RUACH SUBDIVISION

Engineering Comments: FINAL PLAT COMMENTS (should be addressed prior to submitting the FINAL PLAT for review and/or signature by the City Engineer):

APPLICATION NUMBER 3 DATE September 17, 2020
 APPLICANT Ruach Subdivision
 REQUEST Subdivision

DETAIL SITE PLAN

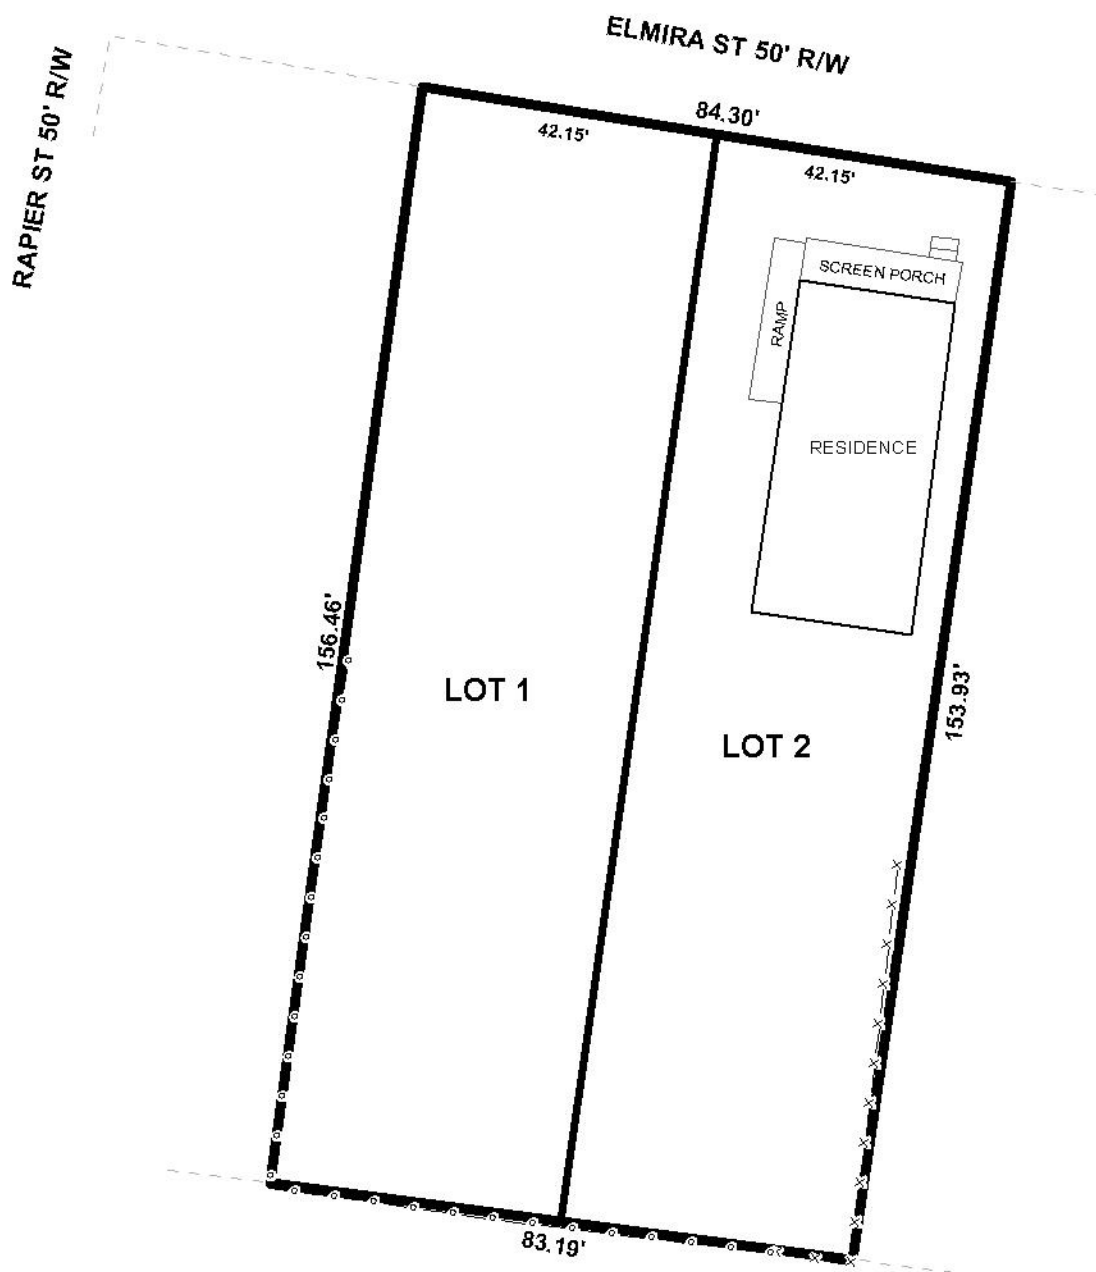
- A. Provide all of the required information on the SUBDIVISION PLAT (i.e. signature blocks, signatures, certification statements, written legal description, required notes, legend, scale, bearings and distances) that is required by the current Alabama State Board of Licensure for Professional Engineers and Land Surveyors.

- B. Provide reference, on the map and the description, to a monumented corner.
- C. Add the Owner's printed name(s) to the Owner's Dedication.
- D. Provide the Surveyor's and Owner's (notarized) signatures.

- E. Revise NOTES #15 to read "As shown on the 1984 aerial photo (FLIGHT 29 - #77) LOTS 1 and 2 will receive historical credit of existing (1984) impervious area towards stormwater detention requirement per Mobile City Code, Chapter 17, Storm Water Management and Flood Control) as follows: LOT 1 – NONE and LOT 2 –1,300 sf.

- F. Add a note to the SUBDIVISION PLAT stating that a Land Disturbance permit will be required for any land disturbing activity in accordance with Mobile City Code, Chapter 17, Storm Water Management and Flood Control); the City of Mobile, Alabama Flood Plain Management Plan (1984); and, the Rules For Erosion and Sedimentation Control and Storm Water Runoff Control.

Both proposed lots front Elmira Street, a minor street with curb and gutter. As the preliminary plat illustrates a compliant 50-foot right-of-way, no frontage dedication is required.

As illustrated, the preliminary plat does not depict a minimum setback requirement. The Subdivision Regulations would typically require a 25-foot front yard setback. However, it is important to note that the subject property is located within the Oakleigh Garden Historic District and as such would automatically be granted relief from the normal building setbacks and site coverage limitation via the more flexible Historic District Overlay under Section 64-3.G. of the Zoning Ordinance. Therefore, if approved, it is recommended that Section V.D.9. of the Subdivision Regulations be waived, and that a note be placed on the Final Plat stating that all setbacks shall be determined by the Historic District Overlay requirements of the Zoning Ordinance.

The proposed lots will not meet the minimum size requirements (60' width at the building setback line and 7,200 square feet of area) of Section V.D.2. of the Subdivision Regulations and will exceed the maximum width-to-depth ratio allowed per Section V.D.3. However, as sub-standard sized lots are common in the vicinity and within historic districts, waivers of Sections V.D.2. and V.D.3. could be appropriate. Additionally, the lot size labels in both square feet and acres should be retained on the Final Plat or a table should be furnished on the Final Plat providing the same information.

As a means of access management, a note containing the Traffic Engineering comments should be placed on the Final Plat.

Based upon the preceding, and with waivers of Sections V.D.2., V.D.3., and V.D.9., the plat meets the minimum requirements of the Subdivision Regulations and is recommended for Tentative Approval, subject to the following conditions:

- 1) Placement of a note on the Final Plat stating that all setbacks shall be determined by the Historic District Overlay requirements of the Zoning Ordinance;
- 2) Retention of the lot size labels in both square feet and acres on the Final Plat or the furnishing of a table on the Final Plat providing the same information;

- 3) Compliance with the Engineering comments: (FINAL PLAT COMMENTS *(should be addressed prior to submitting the FINAL PLAT for review and/or signature by the City Engineer)*): A. Provide all of the required information on the SUBDIVISION PLAT (i.e. signature blocks, signatures, certification statements, written legal description, required notes, legend, scale, bearings and distances) that is required by the current Alabama State Board of Licensure for Professional Engineers and Land Surveyors. B. Provide reference, on the map and the description, to a monumented corner. C. Add the Owner's printed name(s) to the Owner's Dedication. D. Provide the Surveyor's and Owner's (notarized) signatures. E. Revise NOTES #15 to read "As shown on the 1984 aerial photo (FLIGHT 29 - #77) LOTS 1 and 2 will receive historical credit of existing (1984) impervious area towards stormwater detention requirement per Mobile City Code, Chapter 17, Storm Water Management and Flood Control) as follows: LOT 1 – NONE and LOT 2 –1,300 sf. E. Add a note to the SUBDIVISION PLAT stating that a Land Disturbance permit will be required for any land disturbing activity in accordance with Mobile City Code, Chapter 17, Storm Water Management and Flood Control); the City of Mobile, Alabama Flood Plain Management Plan (1984); and, the Rules For Erosion and Sedimentation Control and Storm Water Runoff Control. F. Email a pdf copy of the FINAL SUBDIVISION PLAT and LETTER OF DECISION to the Permitting Engineering Dept. for review at land.disturbance@cityofmobile.org prior to obtaining any signatures. No signatures are required on the drawing. G. After addressing all of the FINAL SUBDIVISION PLAT review comments provide the ORIGINAL (with all signatures except for the Planning Commission, Traffic Engineering, and City Engineer), one (1) copy, and a transmittal letter to the Engineering Permitting Department. They can be dropped off at 205 Government St. or mailed to PO Box 1827, Mobile, AL, 36633.);

- 4) Placement of a note on the Final Plat stating the Traffic Engineering comments: (*Driveway number, size, location and design to be approved by Traffic Engineering and conform to AASHTO standards.*);
